'A' - AUGUST 2020 - CARPORT REDUCE IN SIZE, INCREASED
SETBACK FROM FRONT BOUNDARY

PROPOSED ALTERATIONS & ADDITIONS

for: S. & L. Tully
at: Lot 17, DP 25162, 23 Panorama Crescent
FRENCHS FOREST, 2086

drawing title
SITE PLAN

date: JUNE 2020
scale: 1:100 (A3)
drawing number
DA 03A

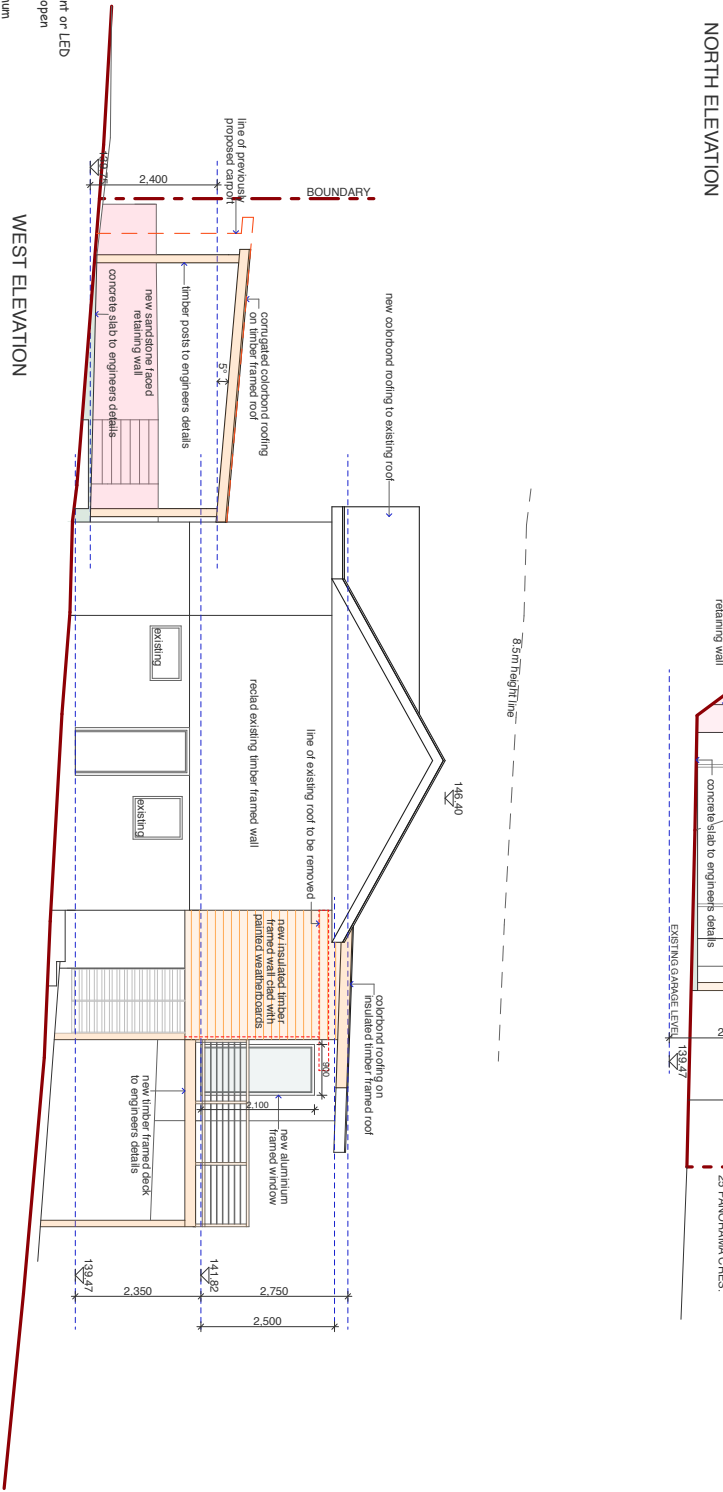
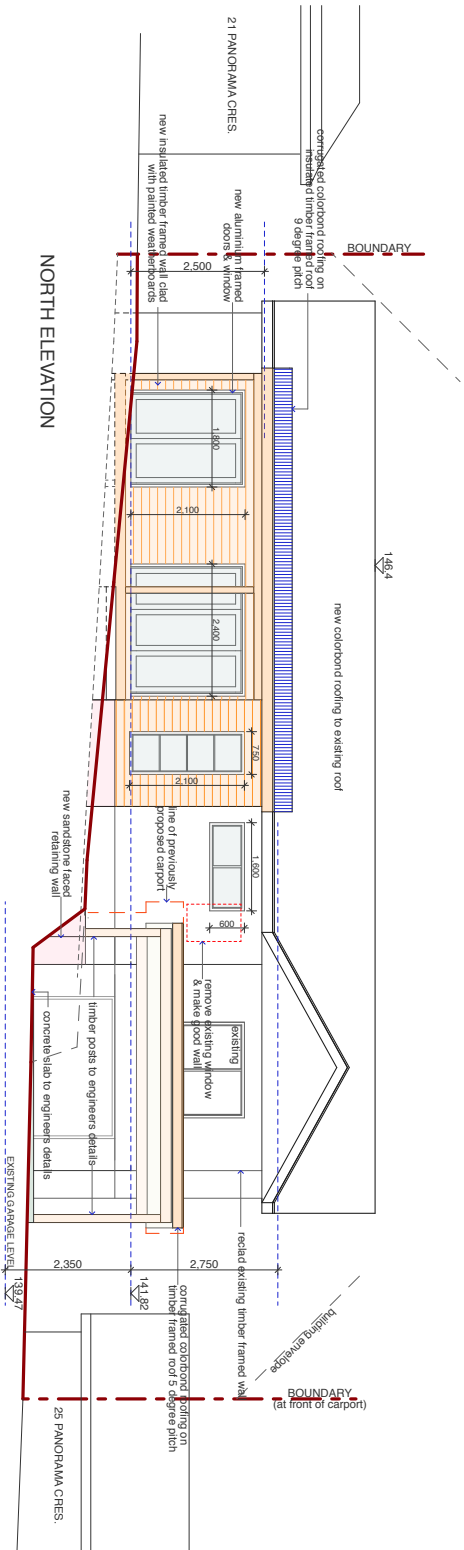
'A' - AUGUST 2020 - CARPORT REDUCE IN SIZE, INCREASED SETBACK FROM FRONT BOUNDARY

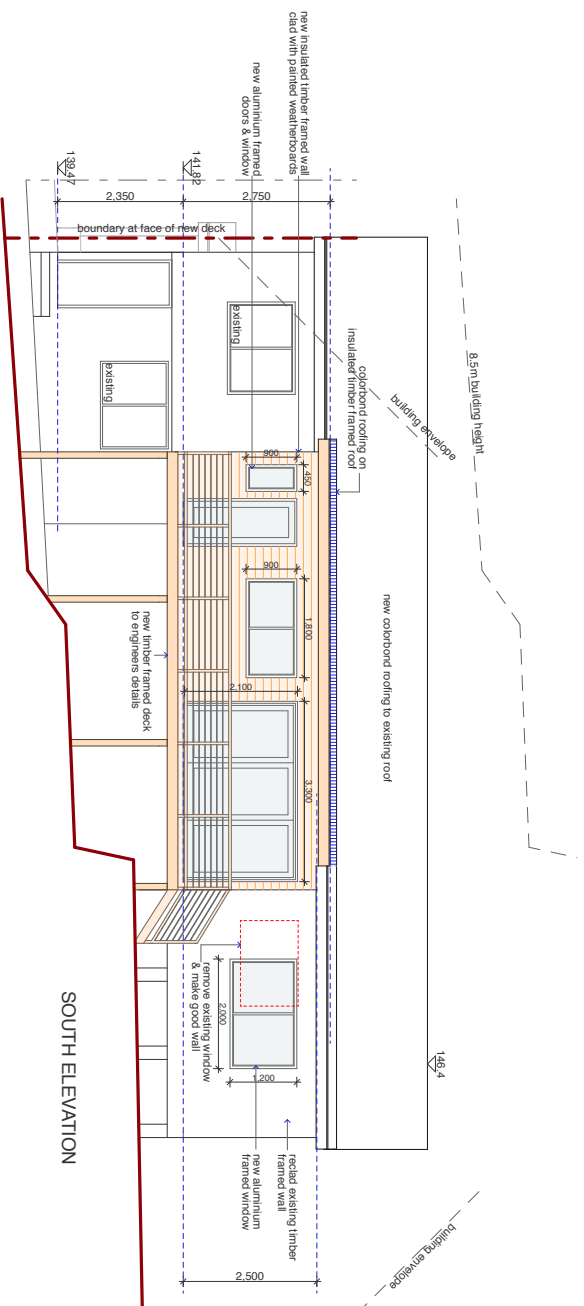
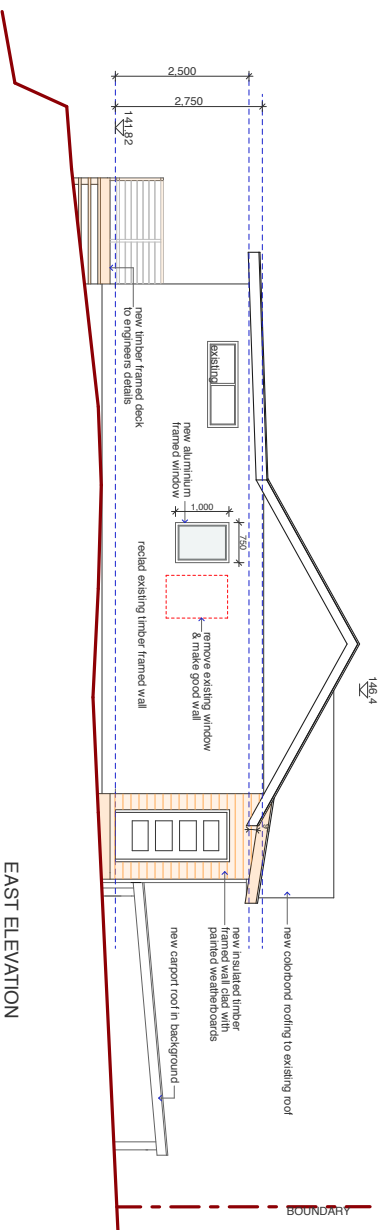
AMENDMENTS		JO WILLMORE DESIGNS 11 Hudson Parade Clareville NSW 2107 (02) 9918 2479 ABN 27 370 370 173		PROPOSED ALTERATIONS & ADDITIONS for: S. & L. Tully at: Lot 17, DP 25162, 23 Panorama Crescent FRENCHS FOREST, 2086		drawing title ELEVATIONS		date: JUNE 2020 scale: 1:100 (A3)		drawing number DA 04A	
'A' - AUGUST 2020 - CARPORT REDUCE IN SIZE, INCREASED SETBACK FROM FRONT BOUNDARY						NOTE: Use figured dimension only. Do not scale off drawings. All levels and dimensions to be verified prior to construction of work
